# UNITED STATES PATENT AND TRADEMARK OFFICE

APPLICATION NO.	FILING DATE	FIRST NAMED INVENTOR	ATTORNEY DOCKET NO.	CONFIRMATION NO.
10/589,929	08/20/2007	Holger Bauer	2003P15370WOUS	3756

<b>Office Action Summary</b>	<b>Application No.</b> 10/589,929	<b>Applicant(s)</b> BAUER ET AL.	
	<b>Examiner</b> PHUTTHIWAT WONGWIAN	<b>Art Unit</b> 3741

## DETAILED ACTION

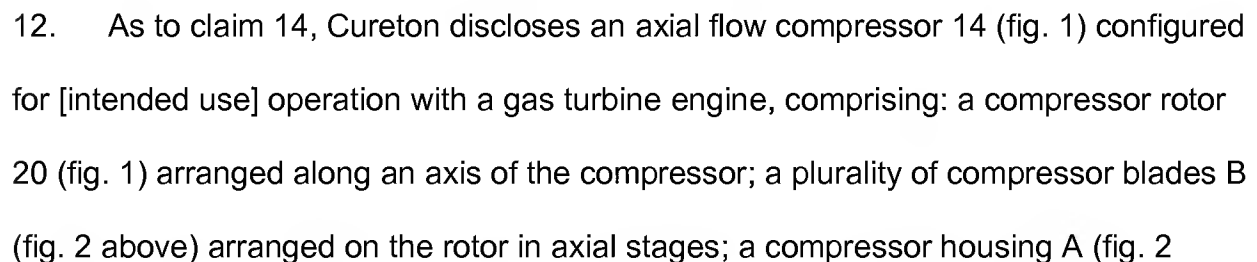
7. As to claim 9, Feulner discloses a gas turbine having a compressor 12 (fig. 1), comprising: a compressor housing 20 (fig. 4) coaxially surrounding the compressor 12 (fig. 4); a cavity 64 (fig. 4) in the housing configured to thermally influence (fig. 4) the housing 20 (fig. 4), and a tap line (fig. 6) in flow communication with the cavity for [intended use] extracting a portion of a compressed fluid flow of the compressor; and a locking device 76 (fig. 4) arranged in line with the tap line 66 (fig. 4) and downstream of the cavity 64 (fig. 4) that locks off the extracted compressed flow through the tap line.

8. As to claim 14, Feulner discloses an axial flow compressor 12 (fig. 4) configured [intended use] for operation with a gas turbine engine, comprising: a compressor rotor 30 (fig. 4) arranged along an axis (fig. 4) of the compressor; a plurality of compressor blades 34 (fig. 4) arranged on the rotor in axial stages; a compressor housing 20 (fig. 4)

coaxially surrounding the rotor; a cavity 64 (fig. 4) in the housing configured to thermally insulate (fig. 4) the housing, and a tap line 66 (fig. 4) in flow communication with the cavity for [intended use] extracting a portion of a compressed fluid flow of the compressor; and a plurality of stationary compressor blades 56 (fig. 4) secured to the housing arranged in axial stages; a locking element 76 (fig. 4) arranged in the tap line downstream of the cavity to block off the flow of removed air (fig. 4).
